MXD
CAMBRIDGE, MA

**INFILL DEVELOPMENT
CONCEPT PLAN**

**AMENDMENT 2
RESPONSE TO COMMENTS**

NOV 5 2021
SASAKI

R.ES FIG. 1

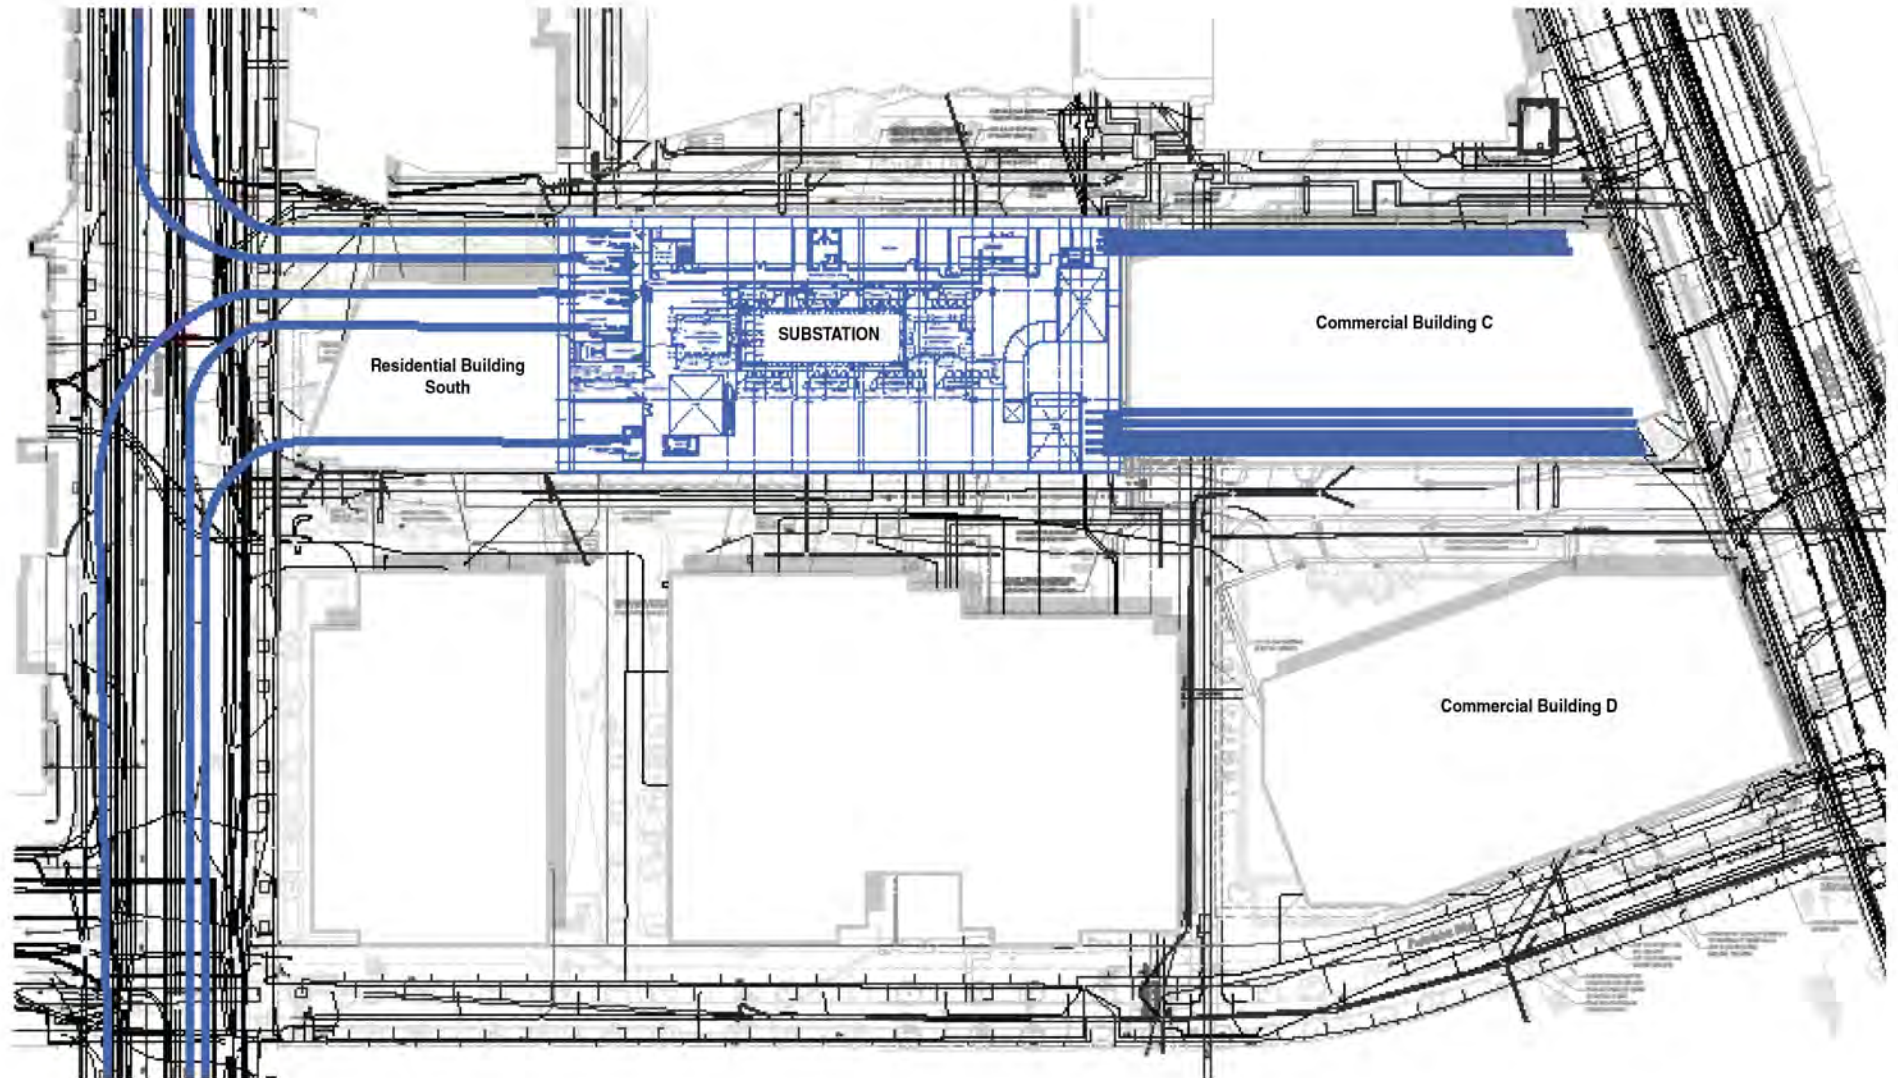
Comment Reference: CRA Staff Letter

The proposed electrical substation vault is planned to occupy a footprint of approximately 285' x 100' x 110' in the approximate center of the current Blue Garage parcel. As presented at the Joint Board hearing on 9/28/21 and discussed during the re-zoning process, this central positioning of the electrical substation is driven primarily by transmission and distribution considerations. The transmission and distribution duct banks pivotal for the proposed substation's operational viability are subject to critical engineering requirements including maximum bend radius constraints, limitations on depth, and minimizing proximity to underground heat sources that degrade electrical capacity. When the extremely crowded subsurface conditions beneath Broadway, Binney, and the Blue Garage service drives are overlaid on the foregoing requirements, the enormous scale of the routing challenge becomes clear.

To date, the interconnected proposed siting for the substation, transmission, and distribution duct banks within Concept Plan Amendment #2 represents the only viable known proposal for effectuating the substation relocation to the MXD. By extension, this configuration of proposed substation infrastructure elements determines the program distribution opportunities available to the Applicant within Concept Plan Amendment #2. Structural elements and subsurface spaces of the proposed commercial and residential buildings must be coordinated with the transmission and distribution duct banks exiting the substation, while the footprint of the substation itself cannot be overbuilt, but can function as public open space.

R.ES FIG. 2

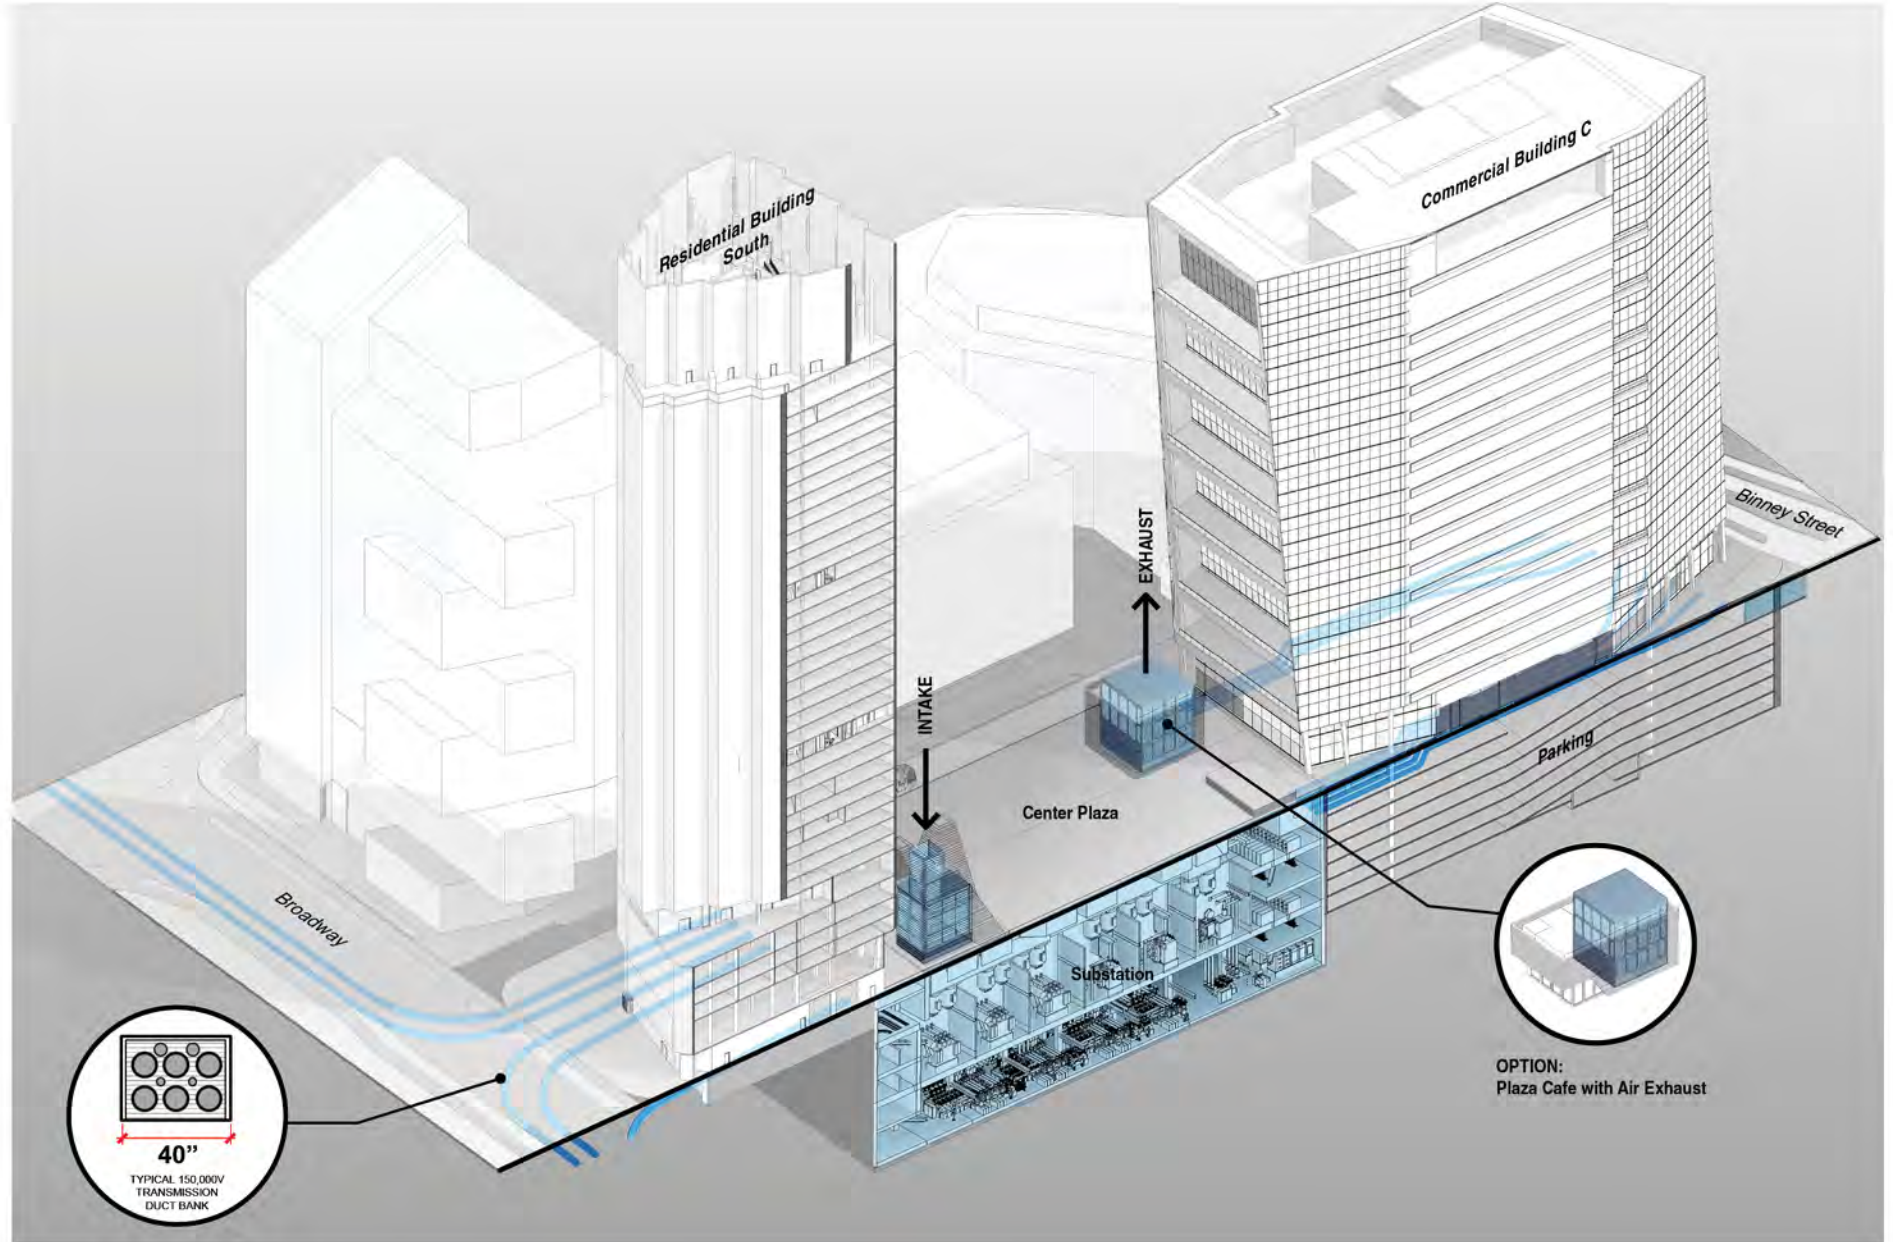
Comment Reference: CRA Staff Letter

While precise details of the interior of the proposed electrical substation must be withheld on account of security concerns, the same logic of space constraints and interdependent engineering decisions applies within the substation vault. The interior of the proposed below grade electrical substation is anticipated to be filled with carefully selected and sited equipment responsive to both the internal needs of the substation's machinery and the positioning of vertical shafts—including ventilation, equipment hatchways, loading elevators, and stairways—that run through the entirety of the substation and ultimately reach its roof. This relationship illuminates the close connection between the nature of the Center Plaza and internal substation engineering requirements and why decisions about the configuration of the Plaza must ultimately be made relative to electrical substation design considerations.

R.1.1 FIG 1

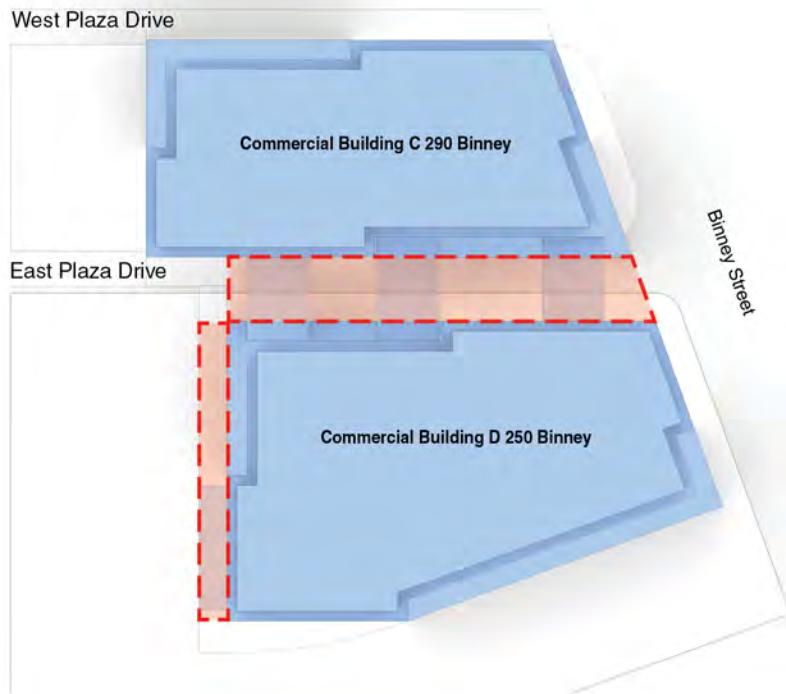
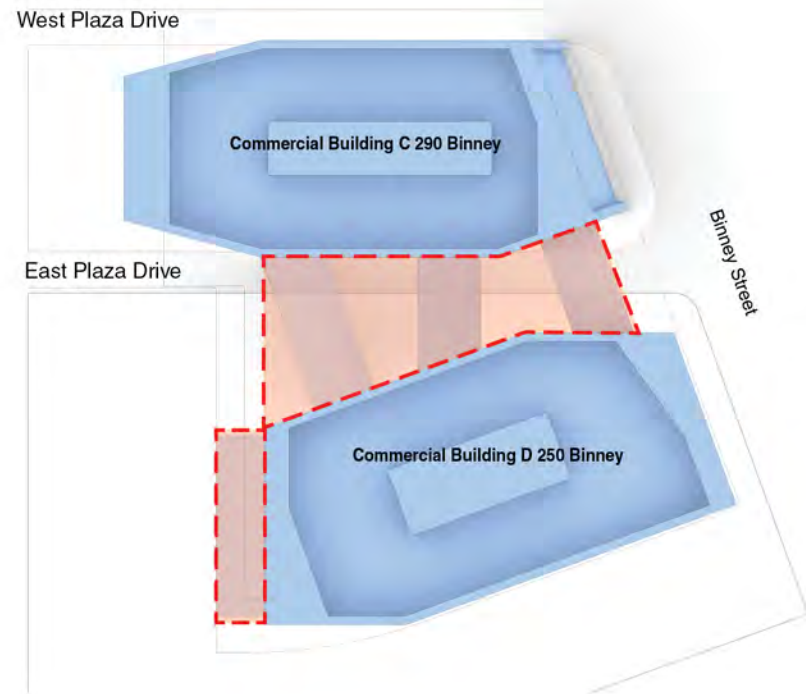
The Applicant received several comments and questions about the massing and the relationship between Commercial Building C and D and the Center Plaza. A discussion of massing concepts for Commercial Buildings C and D must begin with a reckoning of the binding site and programmatic constraints operating at the north end of the proposed redevelopment area. As has been recounted in earlier sections of this response to comments document, the incorporation of extensive substation infrastructure effectively dictates where commercial and residential buildings can be positioned. With transmission and distribution engineering considerations requiring a central positioning of the substation, space for residential and commercial development can consequently only be found to the south and north of the substation itself. This general site constraint is given still further definition when retention of the existing east and west service drives and enhancement of the existing East-West connectors is brought to the fore. This further restricts the footprints for residential and commercial development to the sites depicted consistently in our public meetings and IDCP submissions. Finally, limits on building height mandated by the Cambridge Zoning Ordinance provide the final building envelope constraint that the Applicant intends to work within. Refer to R.1.1 FIG. 1 - FIG. 4 for a visual summary of how these various constraints cumulatively shape the building envelope available for Commercial Building C and Commercial Building D.

Comment Reference: CRA Staff Letter, CDD Staff Letter

Bearing in mind how these constraints shape the building envelope, the next key factor driving the baseline massing concepts for Commercial C and Commercial D is the amount of commercial program that must be distributed between these two available sites. The economic viability of the proposed substation relocation and development plan represented in Concept Plan Amendment #2 depends explicitly on deploying the 800,000 SF of commercial Utility Project GFA contemplated in the recently enacted changes to Article 14 of the Zoning Ordinance (the "MXD Zoning") and Amendment No. 11 to the KSURP approved by the CRA Board on September 16, 2020, and by the Cambridge City Council on February 3, 2021. Without the ability to deliver a net increase of 800,000 SF of Utility Project GFA, the economic cross-subsidies undergirding the needed heavy infrastructure investment become insufficient and render Concept Plan Amendment #2 impossible for the Applicant to complete.

With these major parameters established it is essential to subsequently engage with an important genre of commentary received during the 9/28/2021 Joint Board Hearing. Specifically, assessing the potential value of attempting to consolidate the proposed commercial program within a single building so as to create additional potential for open space within Concept Plan Amendment #2. Relative to market considerations, the notion of a consolidated building incorporating the reconstructed and additional commercial GFA contemplated by Concept Plan Amendment #2 is prohibitive. Delivering the envisioned square footage in one consolidated commercial building represents an unacceptable speculative business risk to the Applicant. Moreover, design considerations suggest a two-building approach to be more advantageous on a number of dimensions including; circulation within the site, access to light and air, creating more human scaled experience. The single building scale would also limit the occupants' access to light and air; a key feature in sustainable building design and human comfort. Based on the design constraints listed above, making a single building on the site would have a negative impact on the community, surrounding site, and building occupants and is therefore not feasible.

R.3.1 FIG. 1

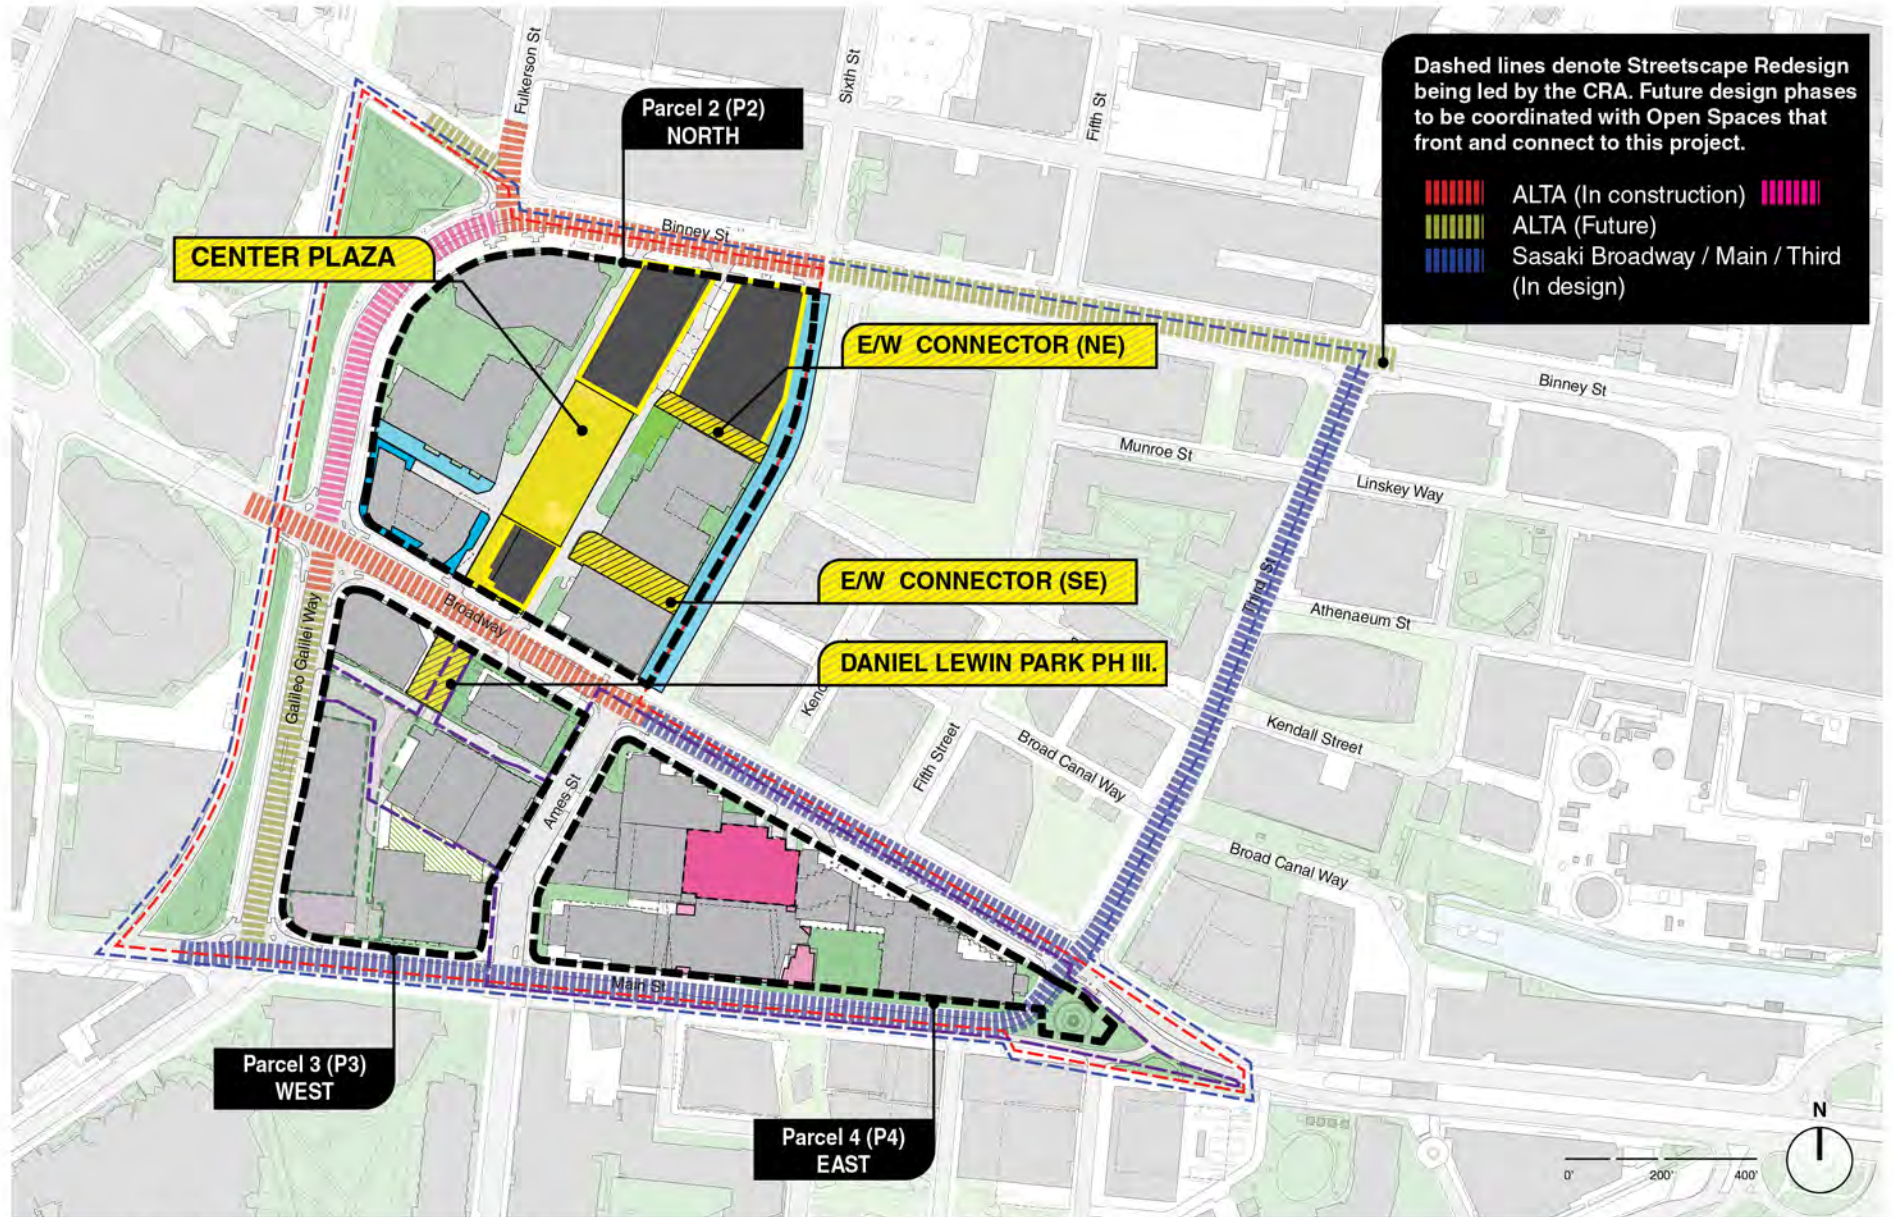
The Applicant received comments requesting additional information on open space proposed by the Project.

Setting aside the opportunity presented by the Fulkerson Street parcel, Concept Plan Amendment #2 contemplates a substantial net increase in open space on a standalone basis. Spurred by requests from community members, City Councilors and the Cambridge Redevelopment Authority (CRA), the Applicant worked diligently with Eversource to prove the feasibility of a below-grade substation within the proposed redevelopment during 2020. This below-grade substation made possible the approximately 30,000 SF Center Plaza public open space currently envisioned at the heart of Concept Plan Amendment #2. Taking this, as well as the East-West connectors and other open spaces created as part of this proposal, Concept Plan Amendment #2 is estimated to deliver a net increase of approximately 17,000 SF of open space within Parcel 2, compared to Concept Plan Amendment #1.

R.3.2.1 FIG. 1

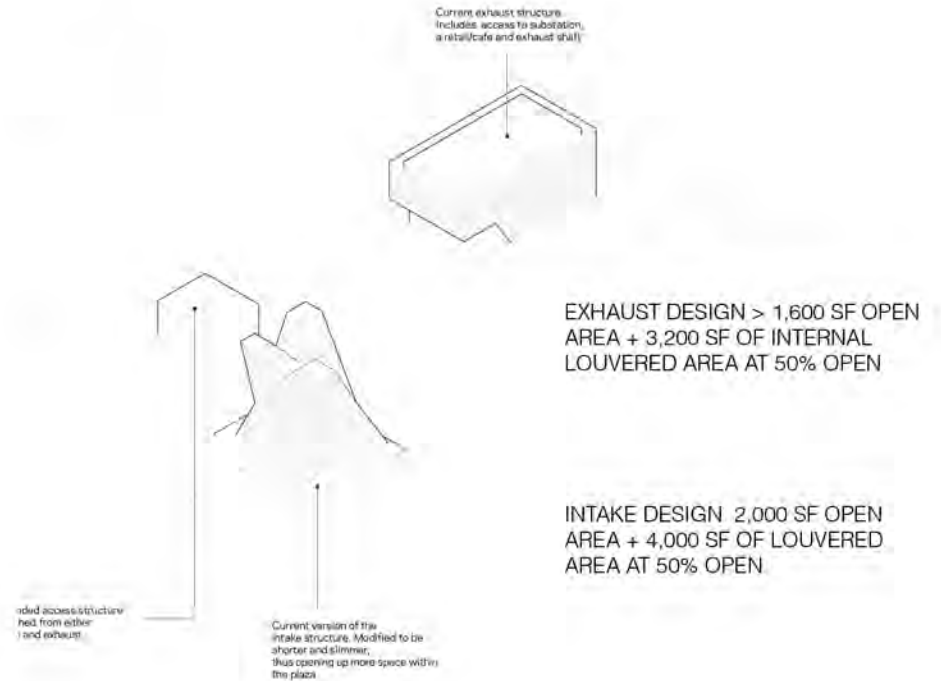
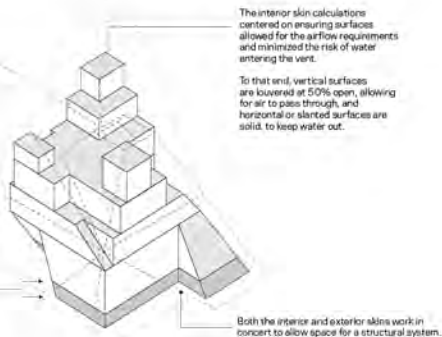
The Applicant received comments requesting additional information on the required ventilation stacks within Center Plaza for the Eversource substation.

First and foremost, it is vital to note that the need for and dimensions of the proposed exhaust and intake structures are rooted in internal substation engineering considerations. The amount of heat that the substation needs to reject, associated calculations of cubic feet of air per minute (CFM) that must pass through the intake and exhaust ducts, and maximum airflow speeds dictate the amount of free area the exhaust and intake structures must have in order to adequately cool the substation facility. These parameters are subsequently influenced by the selection of louvers designed to prevent the intrusion of rain or debris into the substation's ventilation system, which increases the total surface area that must be dedicated to both exhaust and intake structures. For example, louvers with 50% free area require a surface area dedicated to air exhaust or intake 100% greater than the free area initially calculated. Taken together, these variables determine the size of the exhaust and intake structures. The ventilation structures are essential to the functioning of the substation and cannot be eliminated from the proposal.
